**METROPOLITAN GOVERNMENT OF NASHVILLE AND DAVIDSON COUNTY**

**STAFF RECOMMENDATION**  
**1403 Elmwood Avenue**  
**July 20, 2016**

**Application:** New construction-Detached accessory dwelling unit (DADU)  
**District:** Belmont-Hillsboro Neighborhood Conservation Zoning Overlay  
**Council District:** 18  
**Map and Parcel Number:** 10513011900  
**Applicant:** Tucker Tingle, Allard Ward Architects  
**Project Lead:** Paul Hoffman, paul.hoffman@nashville.gov

**Recommendation:**

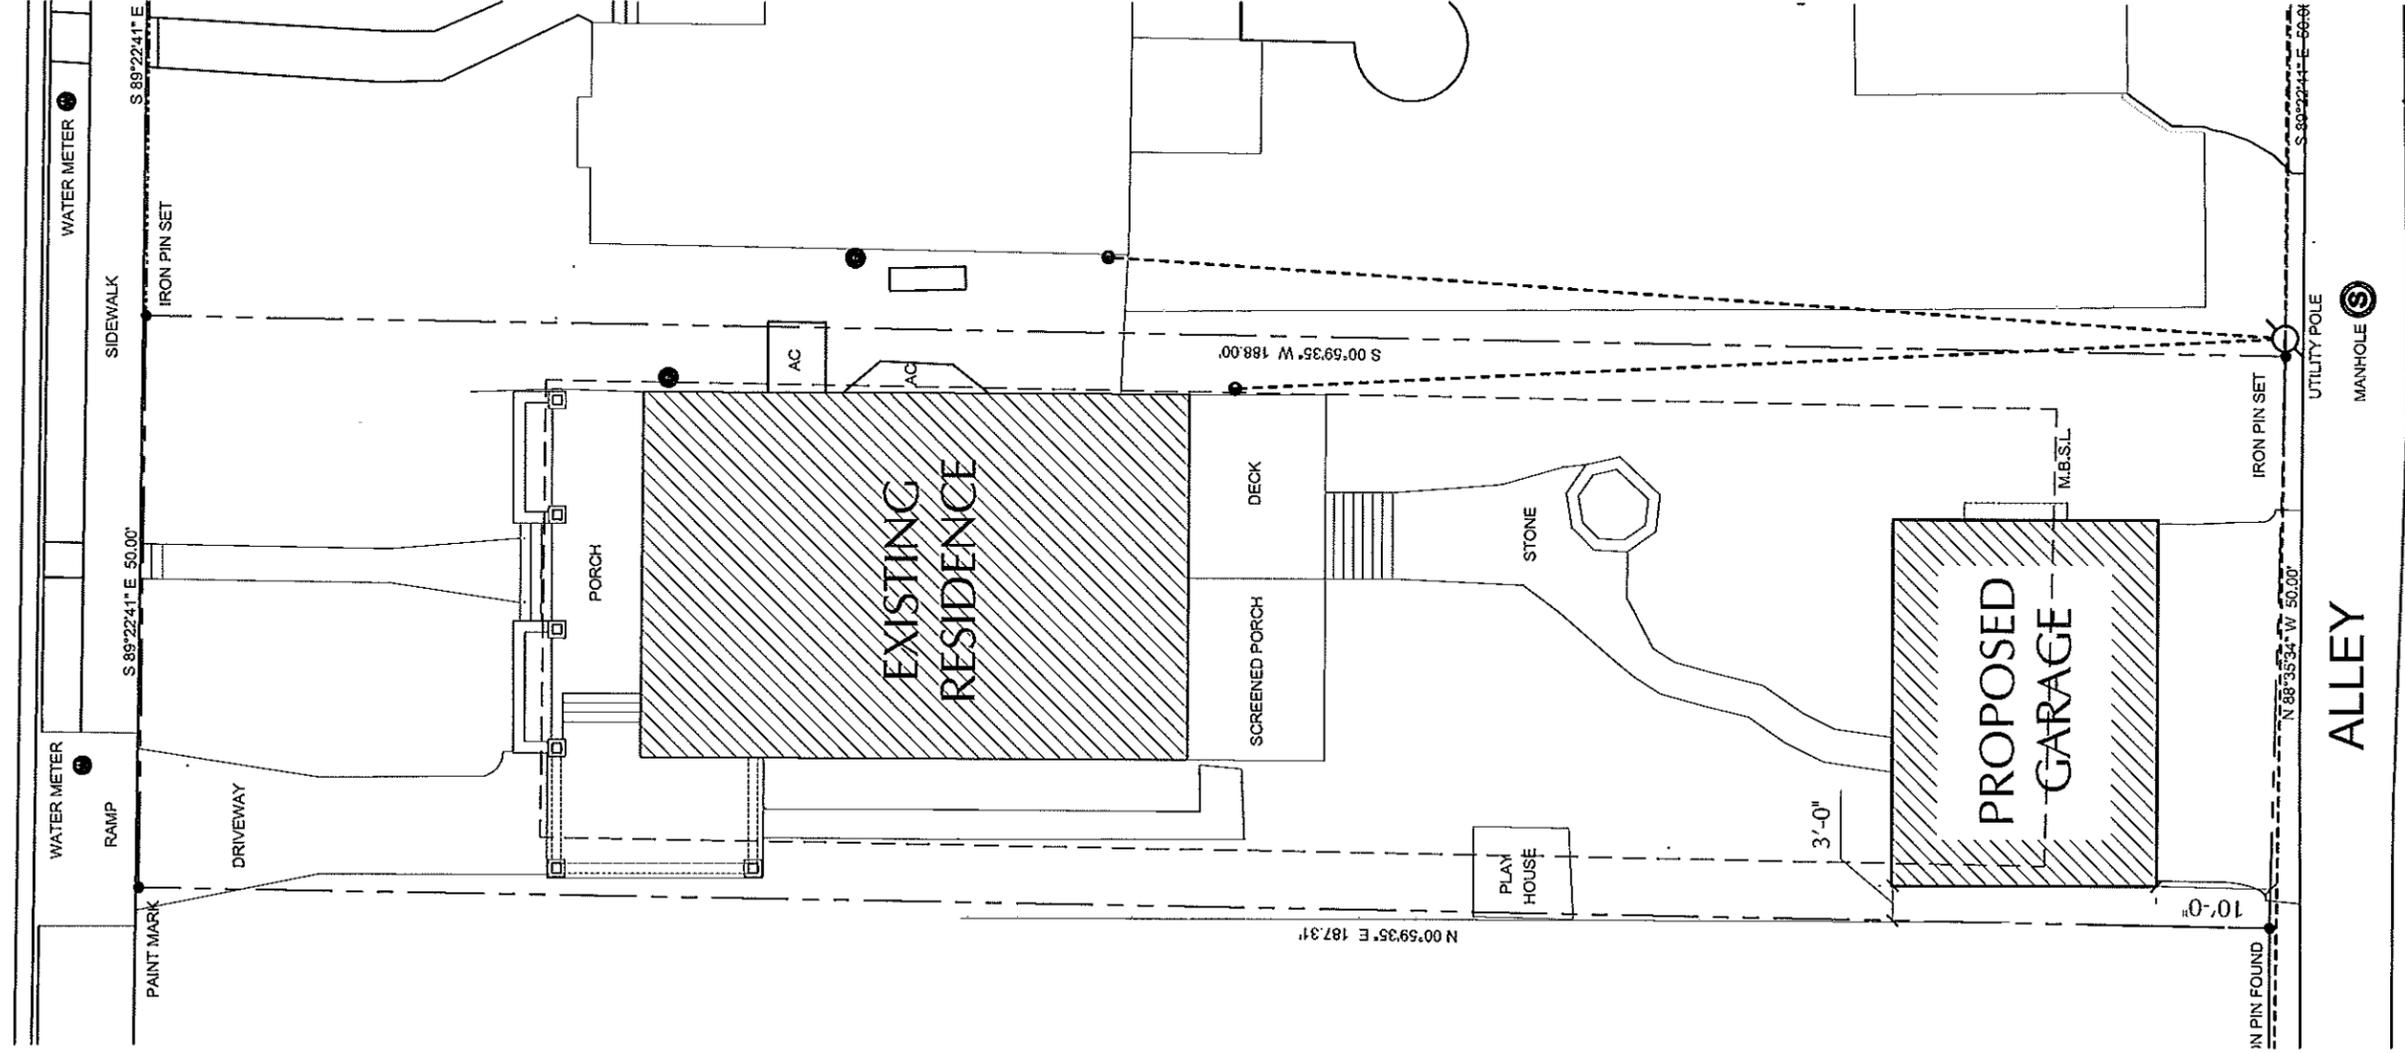
Staff recommends approval of the outbuilding and the setback determination with the conditions:

1. Staff approve the final details, dimensions and materials of windows, doors and garage doors prior to purchase and installation;
2. Siding have a maximum reveal of five inches (5"); and
3. Staff approve the roof color.
